Quanta Computer Inc.
PROJECT : PL3

Size	Document Number	Rev
	Block Diagram	A
Date: Thursday, January 11, 2007	Sheet 1 of 38

change1:SMBUS clock to data wrong connection

Clock Gen I2C

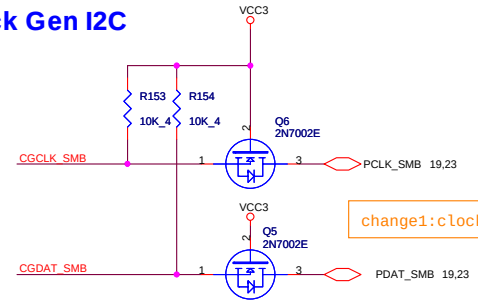
change1:clock to data wrong connection b-test

SMDDR_VREF

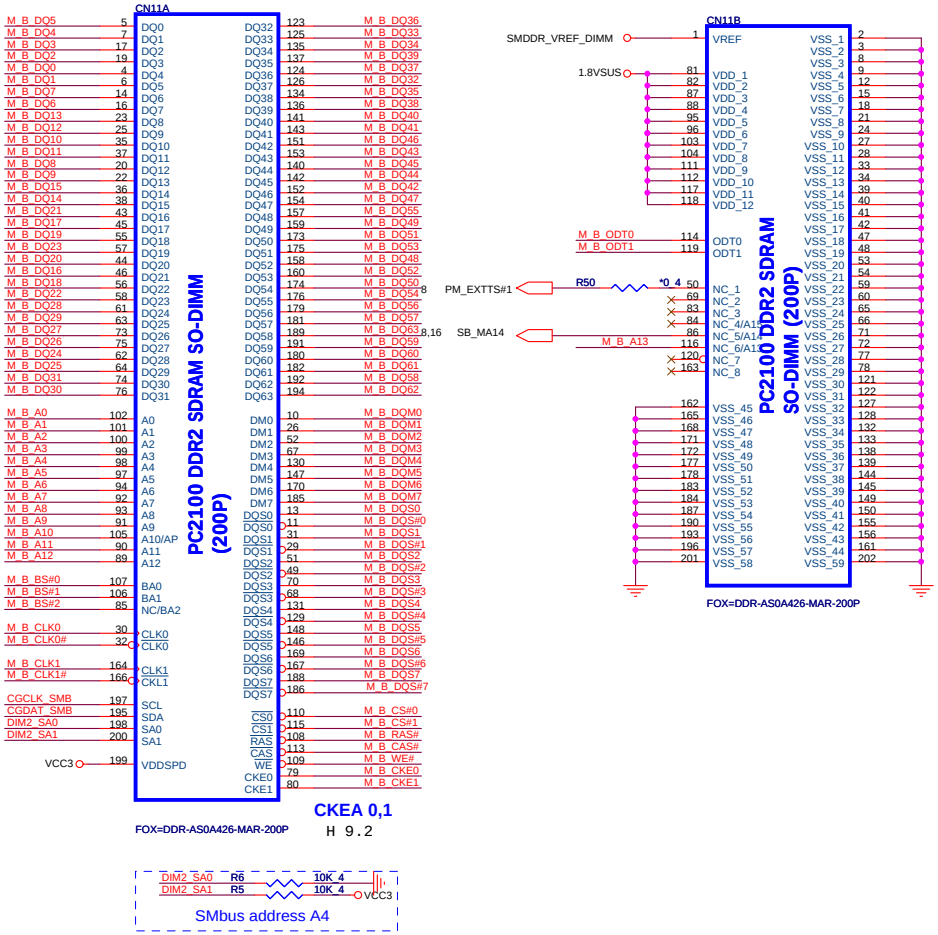
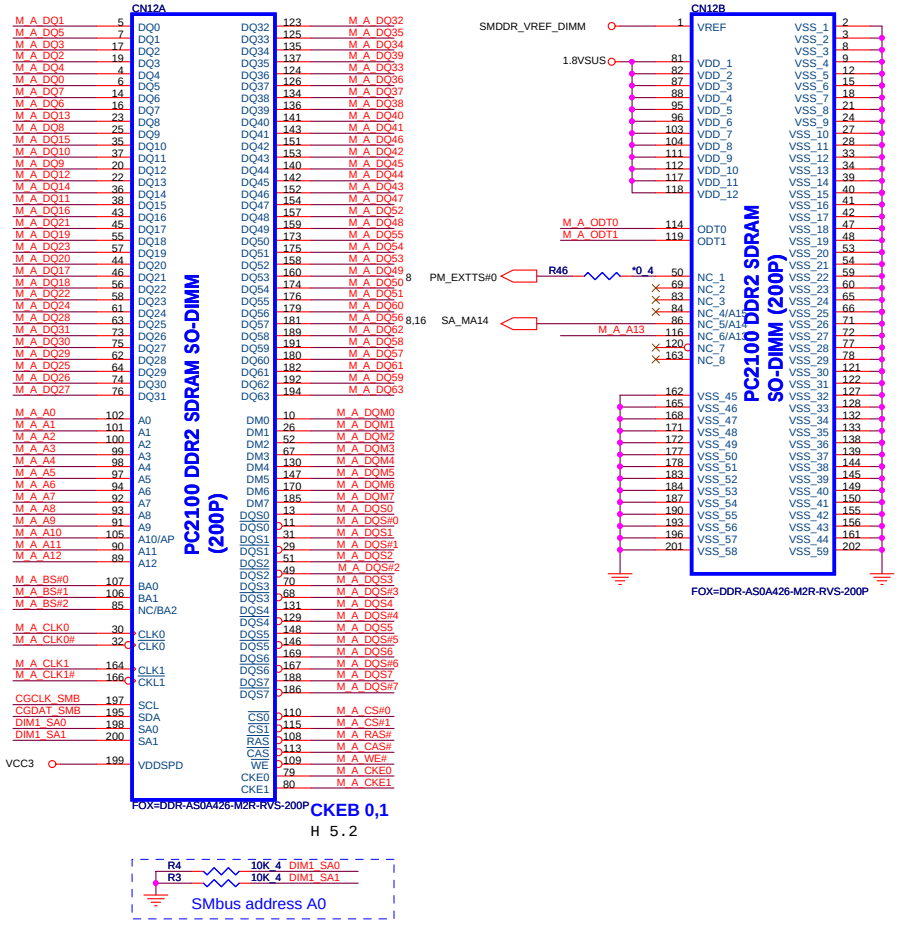
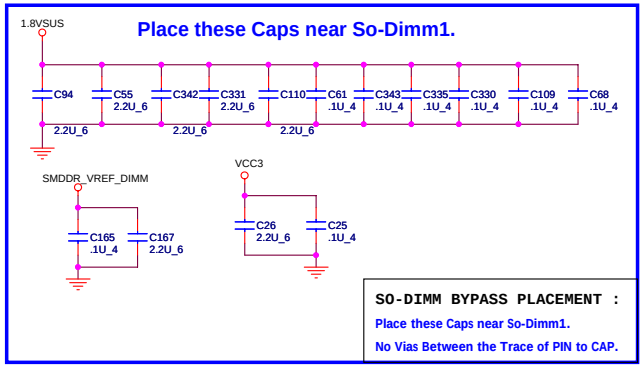
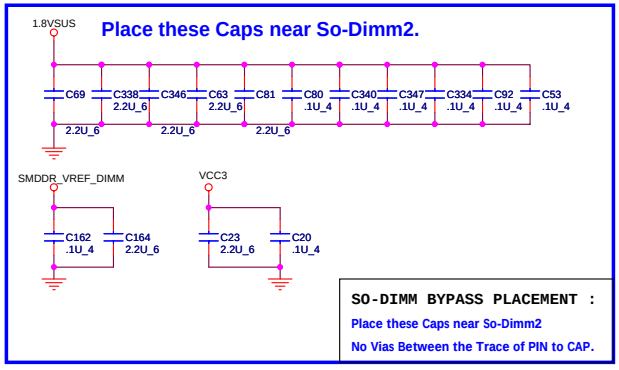
change2:SMDDR_VREF_DIMM is from SMDDR_VREF;
wrong connection of SMDDR_VTERM and SMDDR_VREF

change2:change SMDDR_VTERM to SMDDR_VREF_DIMM in page 15
SMDDR_VREF_DIMM is from SMDDR_VREF;
wrong connection of SMDDR_VTERM and SMDDR_VREF
